United States Environmental Protection Agency 0737

March 4, 1986

This letter addresses issues raised in your October 2, 1985, letter to Mr. A. H. Stallard of the Kansas Department of Transportation (KDOT) on KDOT project number 66-11 K-2587-01. You stated that the proposed bridge replacement project over a Spring River drainage area, 0.36 miles north of junction US-166 within the City of Baxter Springs, Kansas, would be authorized by a nationwide permit. However, letters from our Agency and the Kansas Department of Health and Environment were requested to ensure that special condition 33 CFR 330.5(b)(5) on toxics will be met.

Figure 1. Hypothetical Stream Cross-Section  
(No Scale)

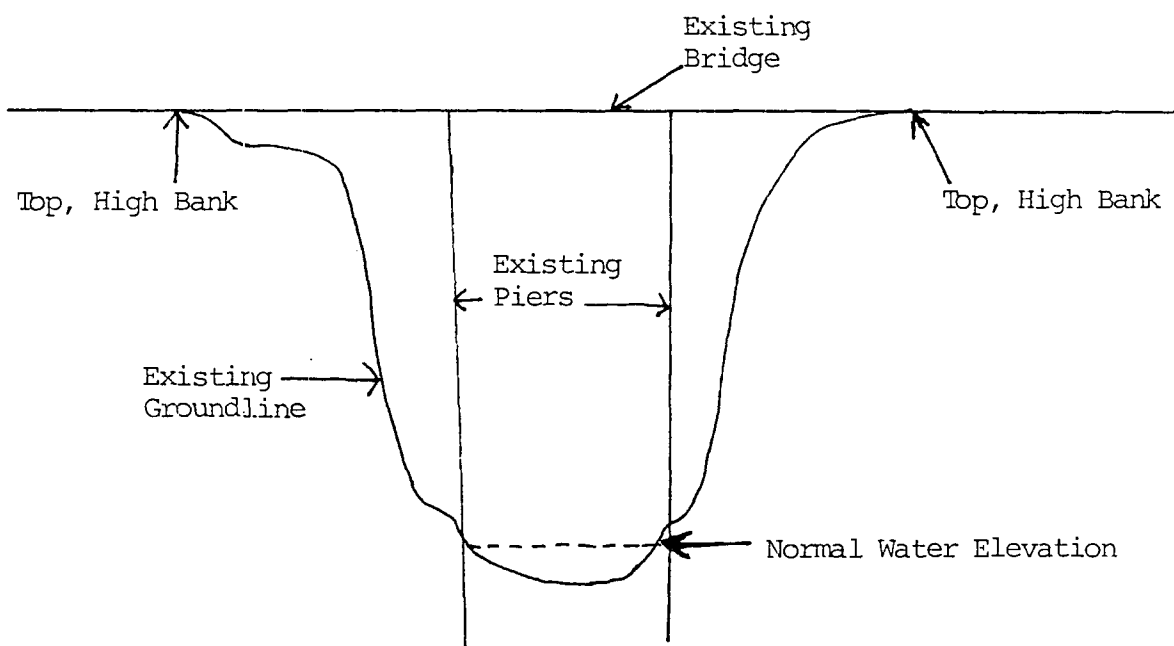
6. It was difficult for us to determine exactly where material within the top, high banks of the stream would be excavated and then redeposited because we had no drawings to go by. Mr. Stallard advised us that all excavated material would be used as backfill, and, therefore, no need to dispose of excess material offsite. He also advised us that material excavated from within the top, high banks of the channel will be placed as backfill behind wing walls, and that pavement would cover part of the excavated material fill. Our understanding is that the excavated material will not be completely covered by the pavement, and that not all excavated material will be placed behind the wing walls. In order to be consistent with the previous KDOT permit (No. 2321) for a bridge replacement project at Riverton, Kansas, and with our October 16, 1985, letter to you on another bridge project over the Spring River, we require that the excavated material be covered and placed in such a manner that it will not come into contact with surface or groundwater. This includes surface water from the stream, from runoff, or from rain. Covering the material will also serve to prevent human or animal contact with the excavated material. Only excavated material placed below the normal water elevation of the stream does not have to be covered (See Figure 1.) We suggest that earthen material above the top, high bank in the bridge and road right-of-way be used to cover material excavated from the stream.
